114 Isabella Street 7-Storey Residential Building City of Ottawa

Development Servicing and Stormwater Management Report

Reference: **114 Isabella Street**
1st Review - Response to Engineering Comments
City File No.: D07-12-20-0040
Our File No.: 119100

| DATE SEPT 2020 | JOB 119100 | FIGURE 4 |

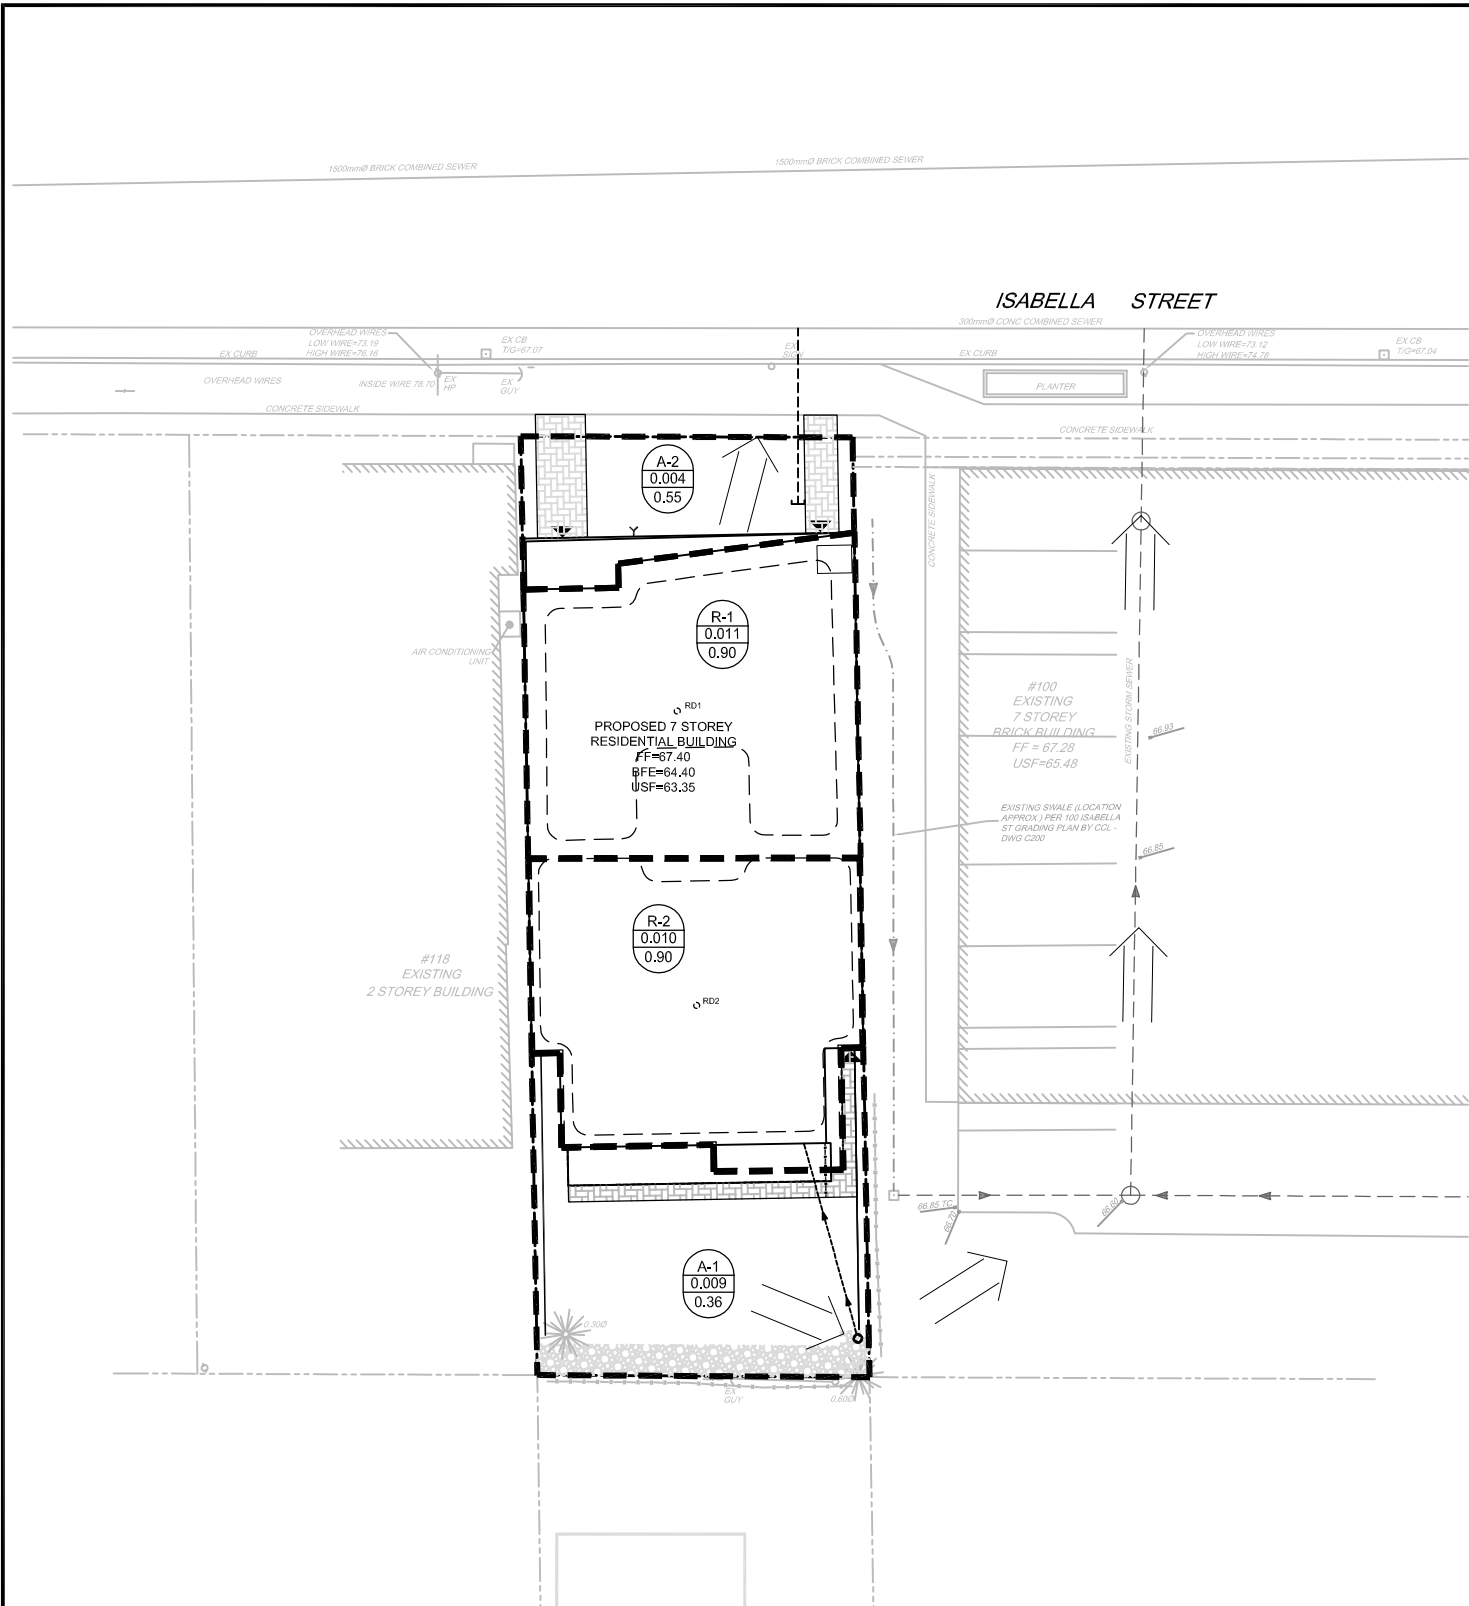
12. On the stormwater management portion there is only one controlled roof. Why is there area R1, and Area R2? The plan does not clearly show where is R1, and R2, in the servicing plan, it shows there are two roof drains. Also why is the R1 using ¼ opening, not closed? We can even reduce the controlled flow, this site's release rate is already over the required control rate. Please review.

Novatech Response: Figure 4, Stormwater Management Post Development, has been revised to show drainage areas R-1 and R-2 which correspond to roof drains RD1 and RD2, respectively. Roof drain RD1 has been set to ¼ open as there is insufficient volume available on the roof at this location to store the 100-year storm event with a fully closed adjustable roof drain.

LOCATION: CITY OF OTTAWA, 114 ISABELLA STREET
DRAWING NAME: GRADING, SERVICING AND EROSION & SEDIMENT CONTROL PLAN
PROJECT No.: 119100
REV: REV # 4
DRAWING No.: 119100-GS

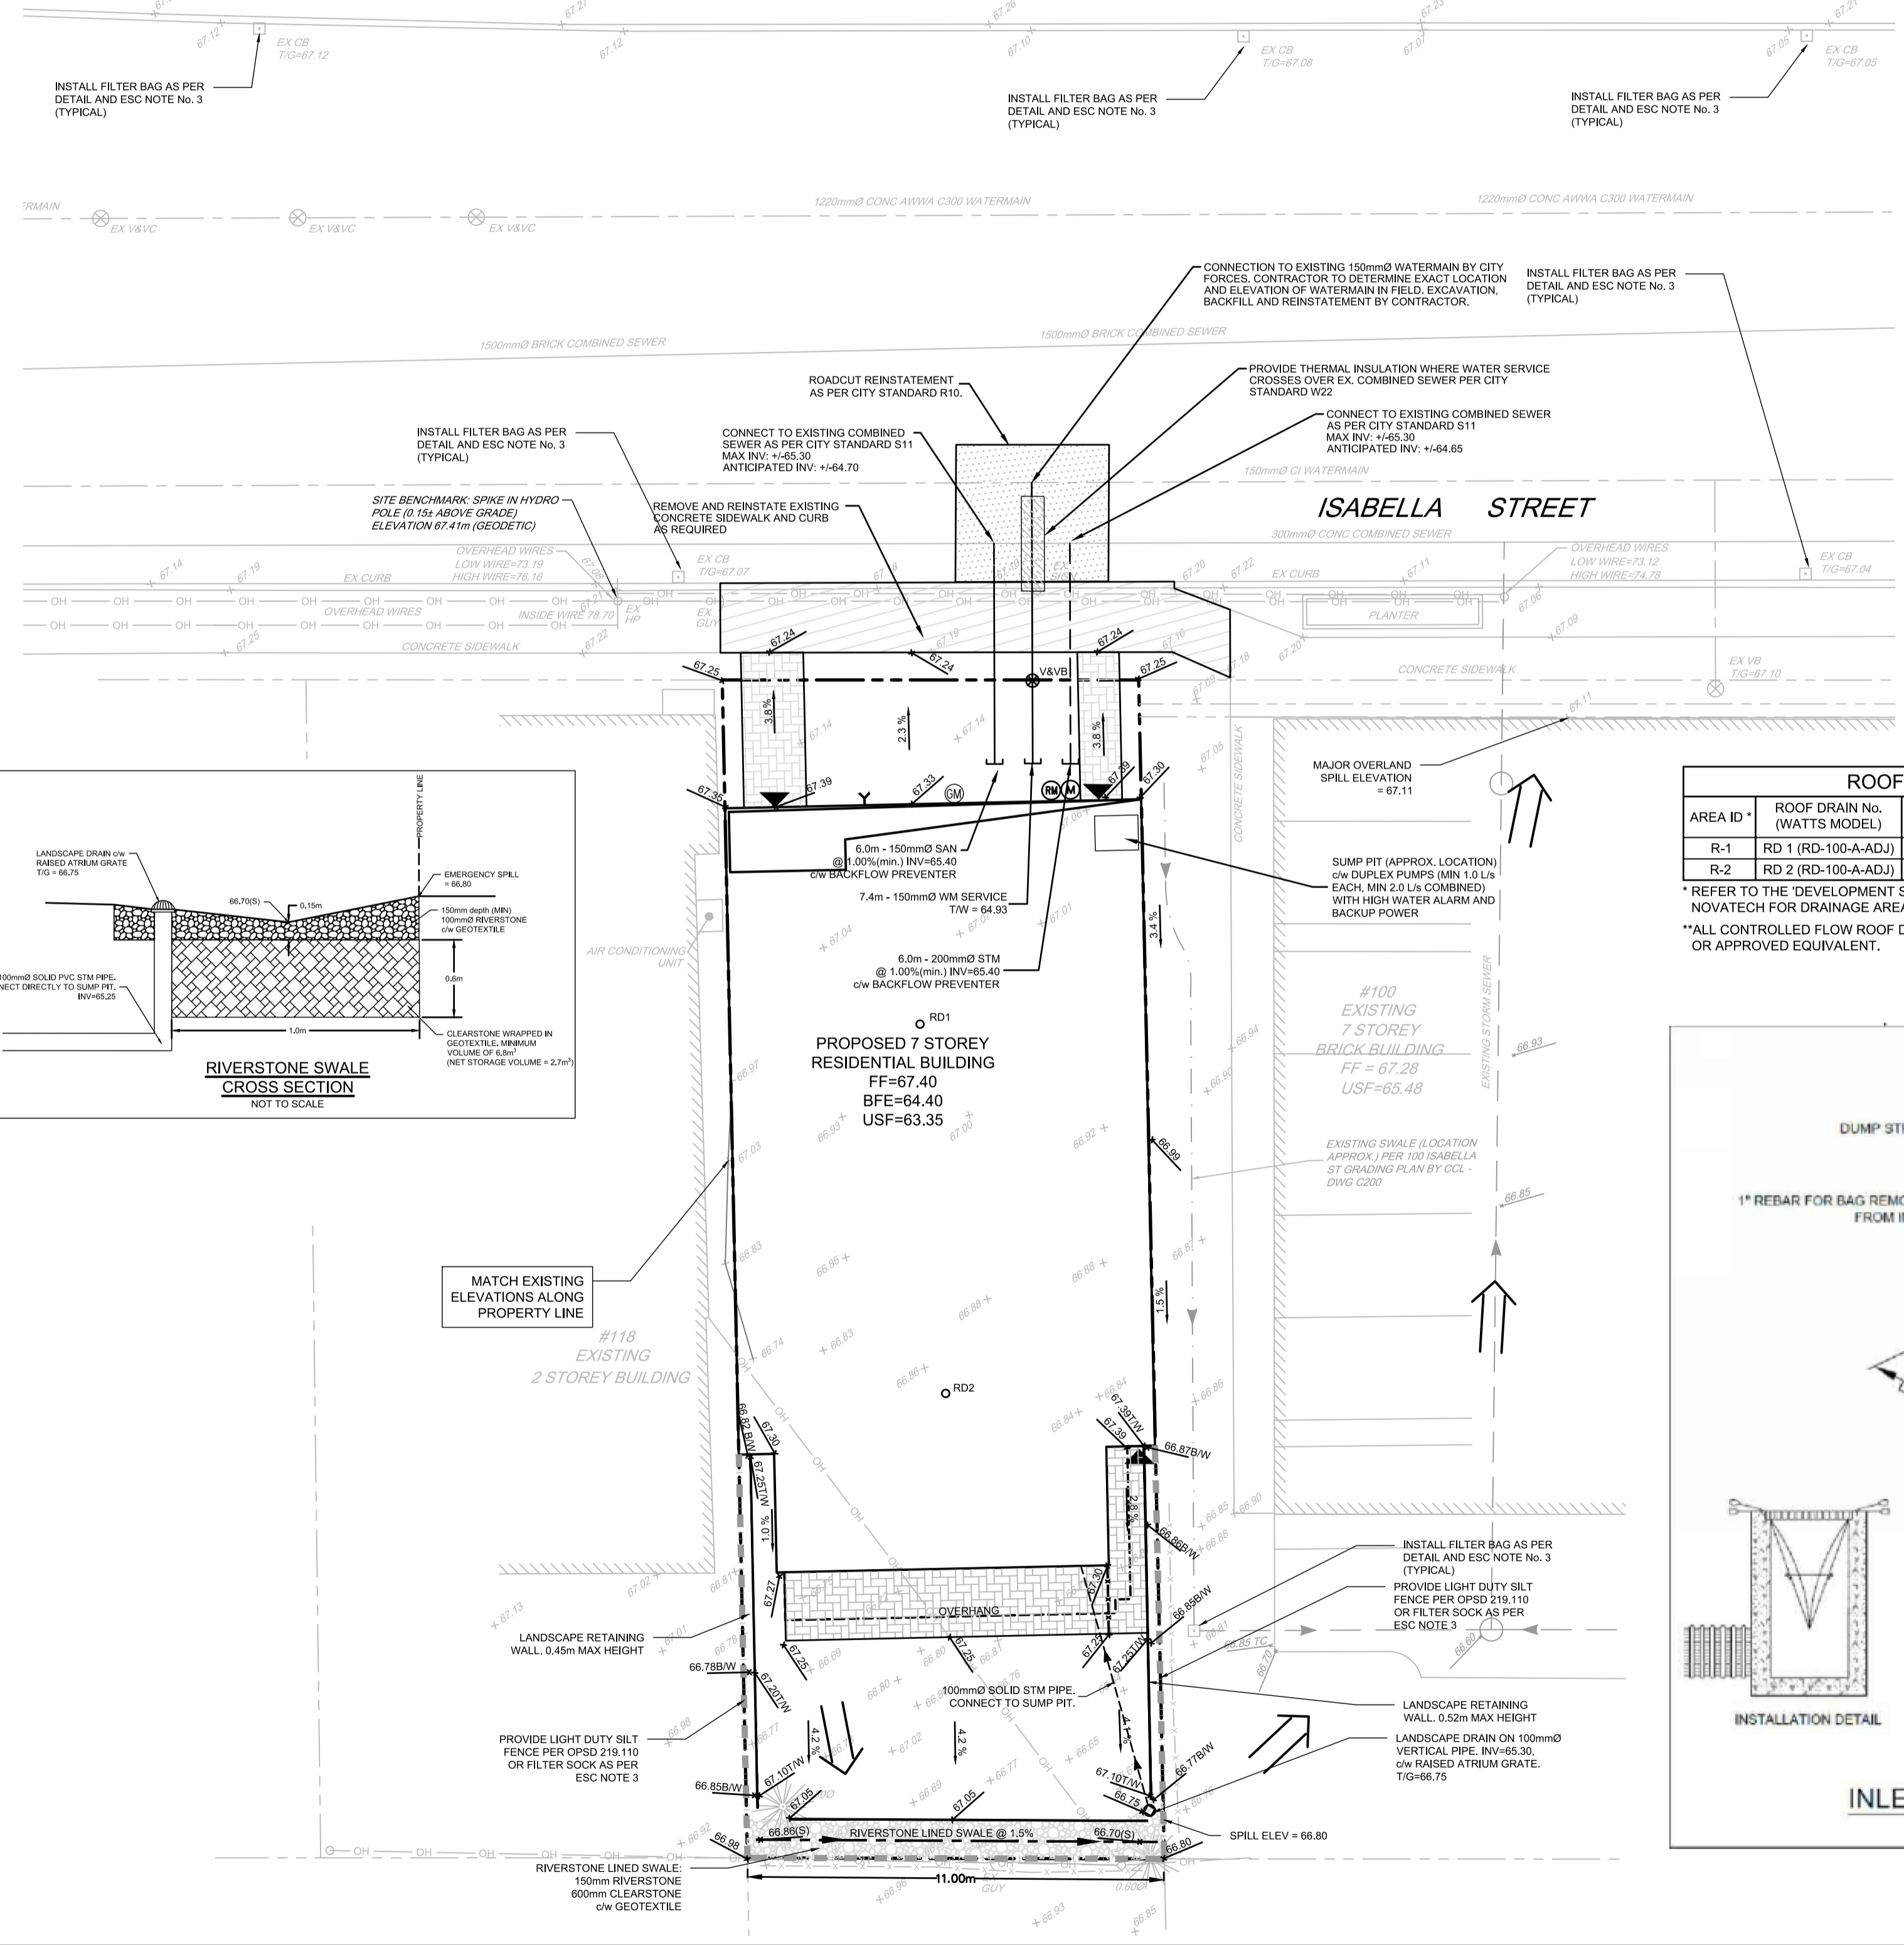
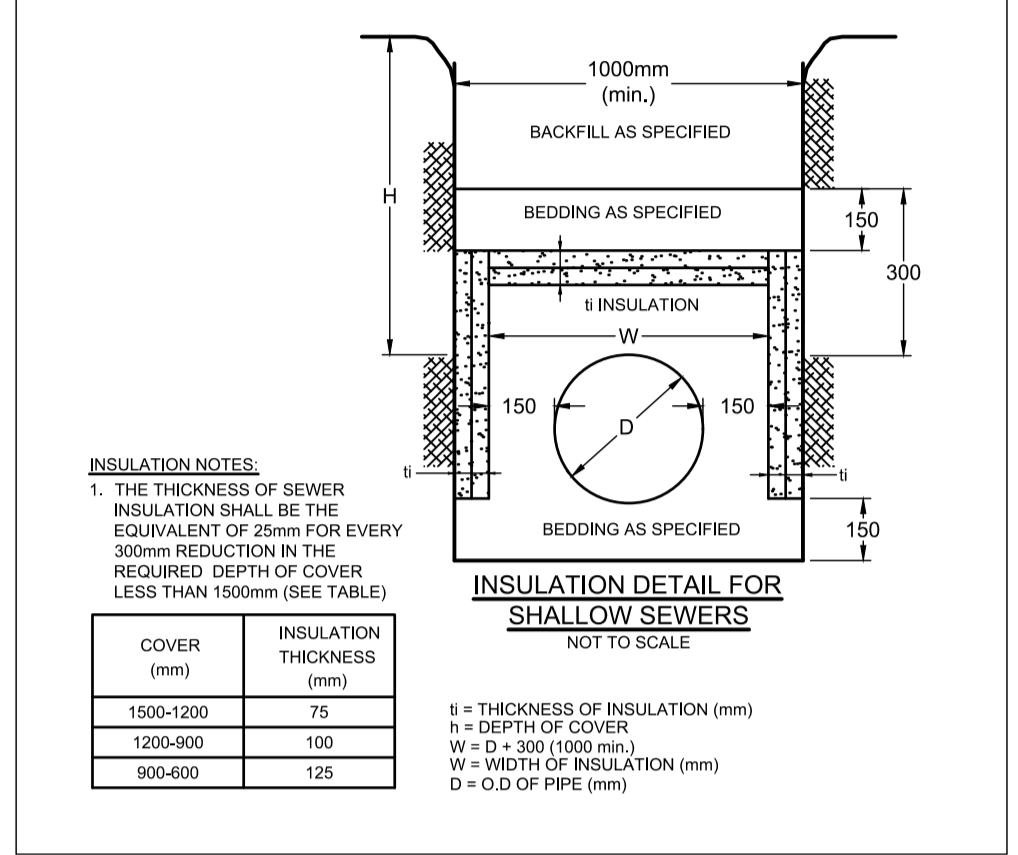
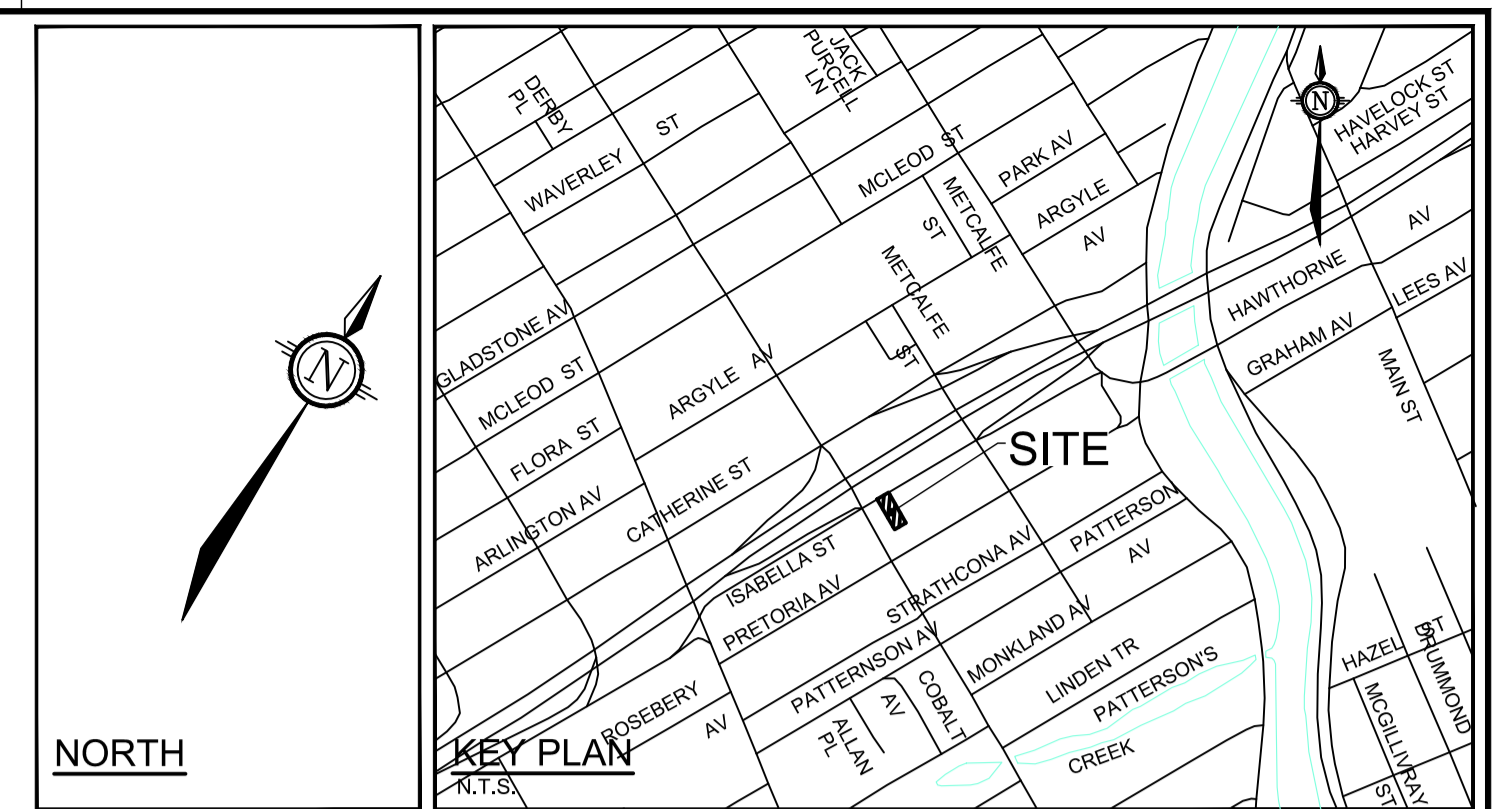
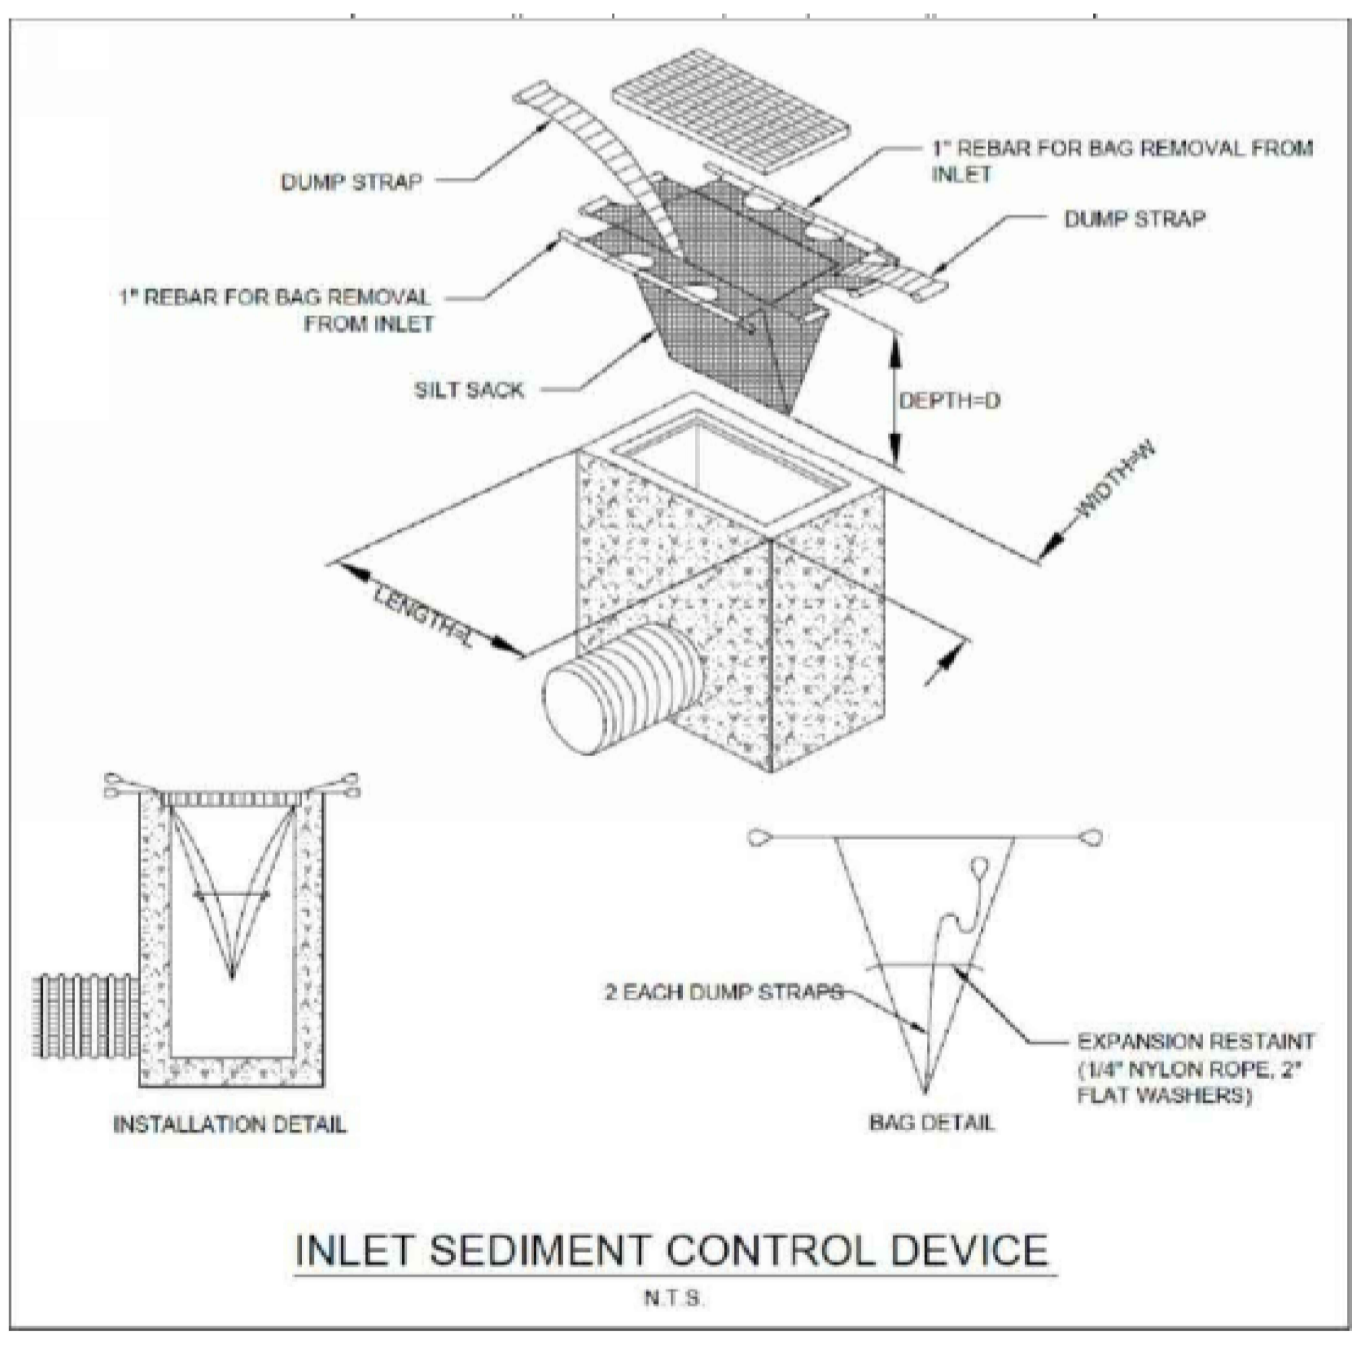
13. The backyard drains to the neighbouring property. Does the owner have an agreement with the neighbour? We need that before we can approve the drainage like that, otherwise the design must change to drain back yard to the front inside your own property.

14. Where is the foundation drain? All sewer connected to combined sewer needs back water valve protection. We do not see it on the drawing.

Novatech Response: The drainage design has been revised so that all storm events up to and including the 100 year volume will be stored and infiltrated onsite via the clearstone trench. In the case of a storm event occurring before the clear stone trench is empty, flows up to and including a 100 year storm will be directed to the building sump pump system and pumped to the existing combined storm sewer on Isabella Street. Emergency overland flow would continue to be to the adjacent property and out to Isabella Street, and is indicated on the Grading and Servicing Plan. Refer to the revised Grading and Servicing Plan and Appendix E of the report for details.

Novatech Response: The foundation drain is located at the front right corner of the building, and a backwater valve has been indicated.

Novatech Response: Based on further review of the servicing plan for the adjacent 100 Isabella Street, the water service does not cross the 114 Isabella Street property. The Grading and Servicing Plan has been revised.
